TransCell 1900TM
47CFR2.10XX Compliance

Document No. X15
March 9, 2001
Revision –

In addition to exhibits already submitted, the following details are furnished in response to the notice generated by Elite regarding outstanding issues with the current application for FCC certification of the TransCell 1900TM system.

Figure 1-1. Typical PCS Flat Panel Antenna.

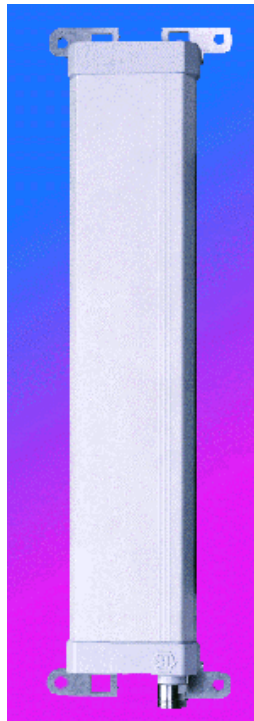
1.1   2.1033C(4)

In addition to photos furnished by Transcept in exhibits C and D, and in 47cfr2_1033.pdf, the following figures are offered.

Figure 4-1. TDMA Input Signal.

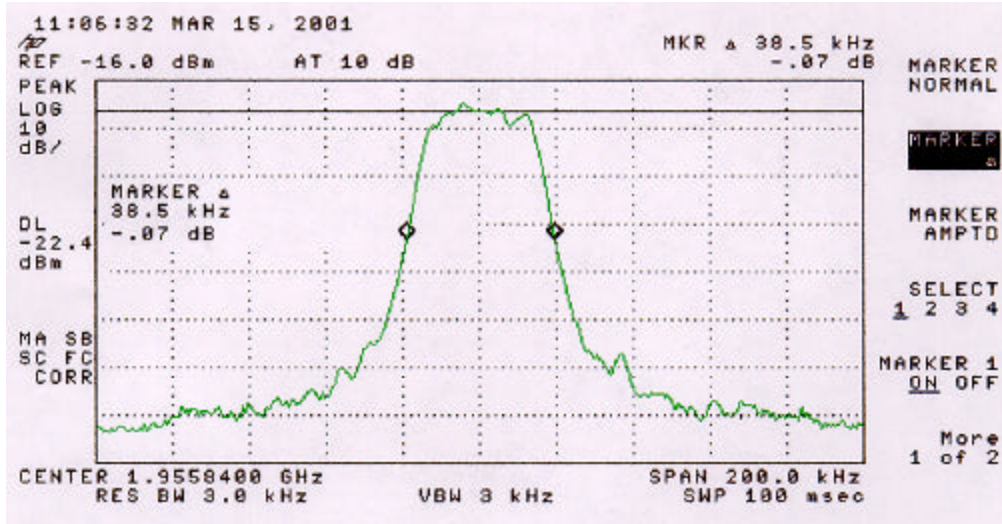
4.2   2.1049C(4)

The nominal TDMA input signal used is shown in Figure 4-1 below. This modulated TDMA signal was generated using the Agilent E4433 specified in Exhibit E of the part 24 submittal. See Exhibit E for a typical 15.247 output waveform.

Figure 8-1. 5.8 GHz Duplexer at Transmitter Output.

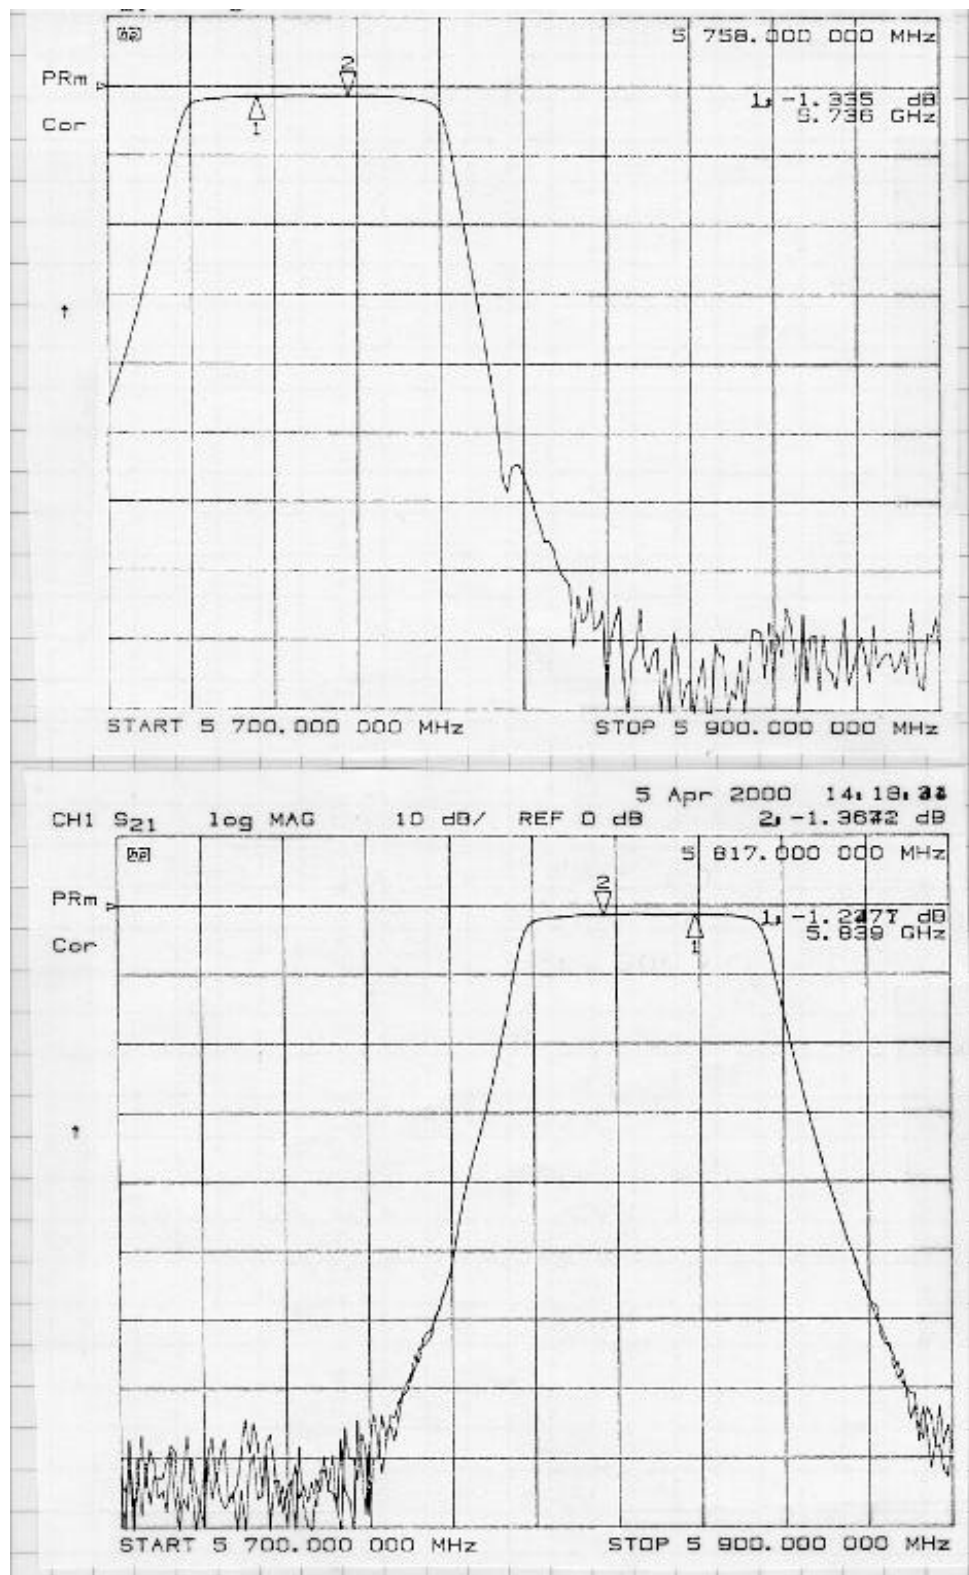
8.0　47CFR2.1057

This spurious data test is documented in Exhibit E6. There are no measurable harmonic or spurious outputs outside the band of 5725 to 5850 MHz. This is due to the rejection provided by the internal filtering of the datalink duplexer. Out of band rejection is equal to or greater than 60 dB. See Figure 8-1 for a typical duplexer sweep.
